Addendum 02

PROJECT: Shenandoah School Corporation New Transportation Center
5100 North Raider Road
Middletown, Indiana 47356

PROJECT #: 25107.00

This addendum form is a part of the Contract Documents and modifies the Construction Documents dated September 2, 2026, with amendments and additions noted below.

SHEET TITLE:
SITE UTILITIES PLAN
SHEET NUMBER:
C1.0

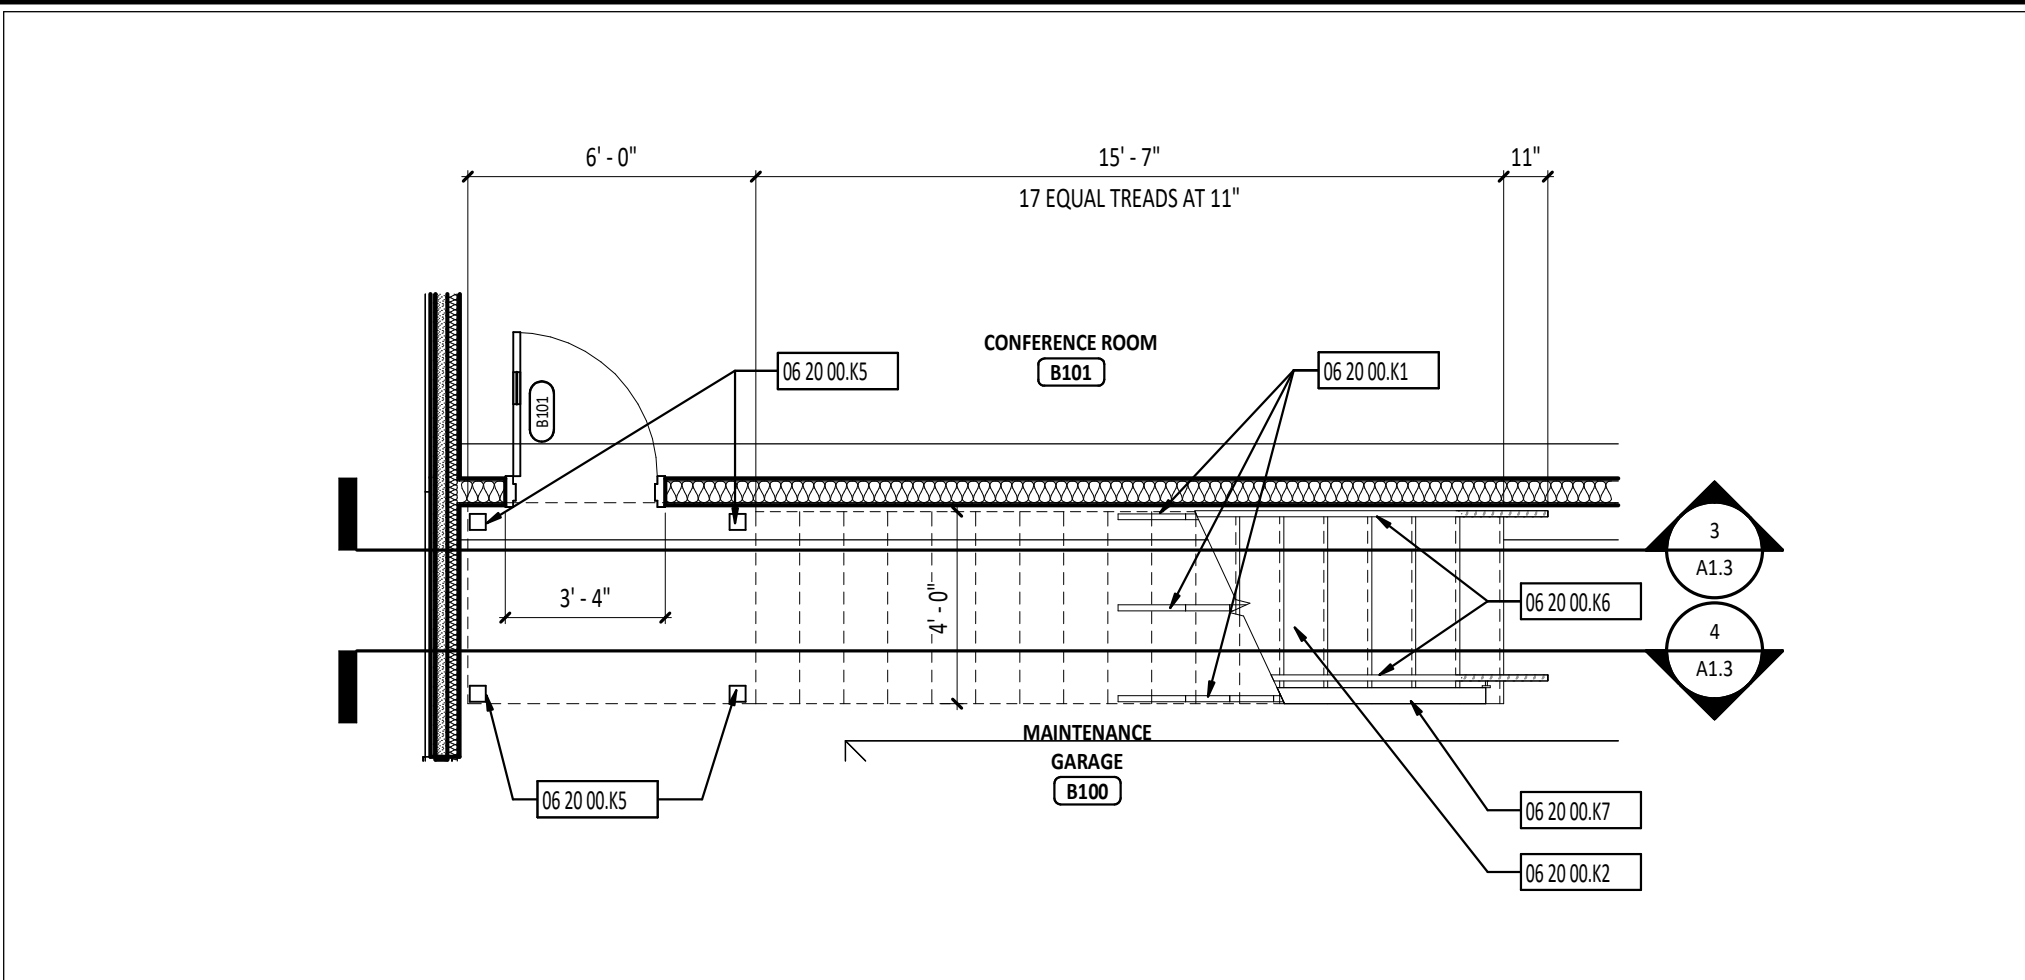
1. Drawing Sheet C1.0 - Site Utilities Plan
 - a. Add cleanouts for the sanitary sewer lines.
2. Drawing Sheet A1.3 - Enlarged Stair Plans, Sections, Details
 - a. Revise keynote 06 20 00.D to be a painted finish.
3. Drawing sheet A6.1 - Door Schedule and Details
 - a. Remove door B203 from door schedule.
4. Drawing Sheet A9.1 - Finish Plans and Details
 - a. Add keynote 09 91 23.A3 to paint wood trim wall cap PT1.
 - b. Add Hardened Concrete to finish schedule.
 - c. Revise floor finish in room B100 to be HC.
5. Drawing Sheet E2.1 - Service Entrance Conduit
 - a. Keynote 15 updated conduit size from 2 inch to 4 inch.
6. Drawing Sheets E1.2, E5.1, E5.2 - Powersync control panel alternate
 - a. Control panels added for alternate Powersync bus heater circuit controls.
